**Town of Kittery Maine
Town Planning Board Meeting
June 25, 2020**

ITEM 1 –Route 236 – Preliminary Site Plan Review

Action: Accept or deny application. Schedule Public Hearing; site wk. Owner/applicant Robert T. Brennan, Jr. requests consideration of a preliminary site plan for a 1,672 sf 1-story building proposed for a car wash on a 324,233 sf lot located at the corner of Route 236 and MacKenzie Lane (Tax Map 289, Lot 25D) in the Commercial (C-2) Zone. Agent is Ryan McCarthy, Tidewater Engineering, Inc.

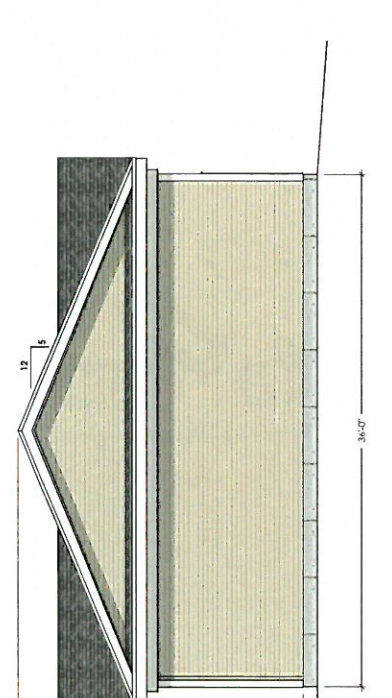
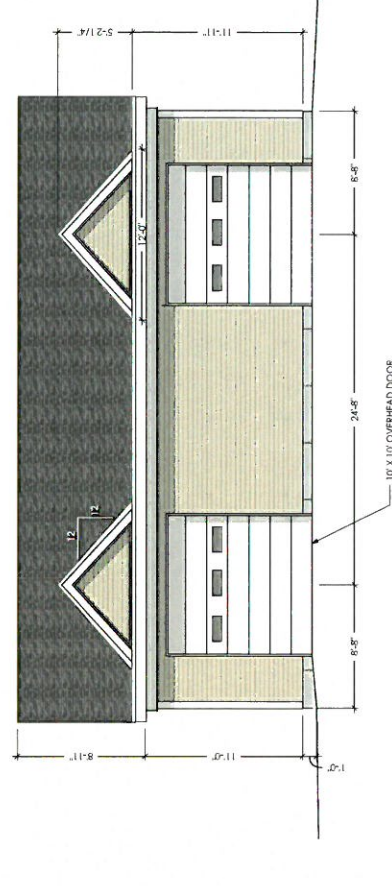
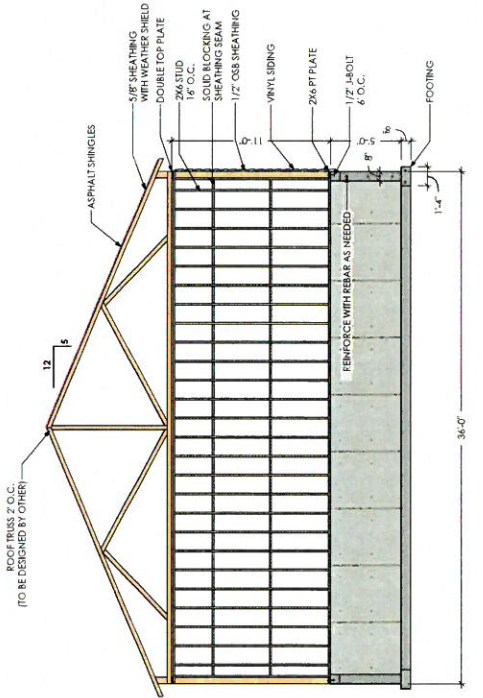
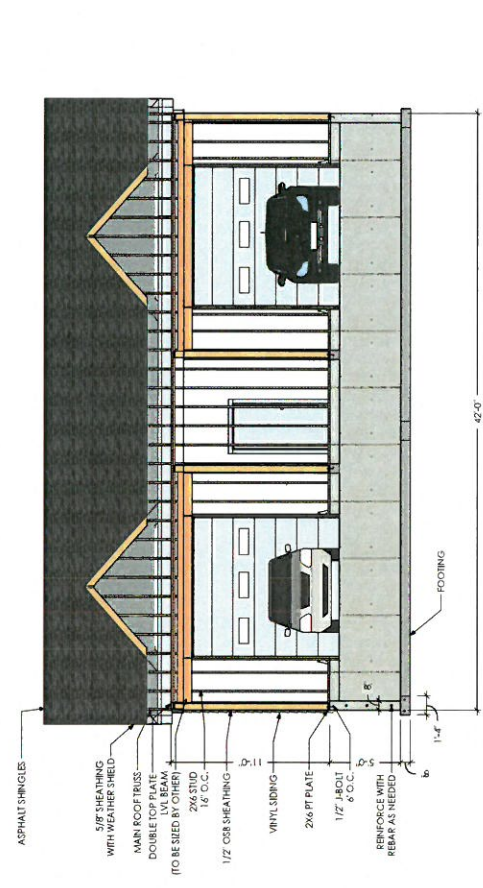
6. The building is proposed to have asphalt roof shingles and vinyl siding with garage doors to close when the wash bay is not in service.
7. The building has a gabled roof with dormers over each bay which meet the minimum of 4:12 pitch requirement (by being 5:12).

Ryan, does the roof pitch meet the 4:12 requirement? It looks like it probably does but there isn't anything on the architectural drawing saying so.

The designer has provided an updated architectural that has more detail and labels the roof pitch. See attached. Do you mind simply swapping out this one for the outdated one? I can drop off 15 copies outside your office door if you want me to provide the prints.

I'm calculating the roof pitch on the primary gable end to be 5:12 and the smaller reverse gables as 12:12 but I'm double checking with the building designer. That should have been labeled on his plan so I'll make sure it is added to future submissions.
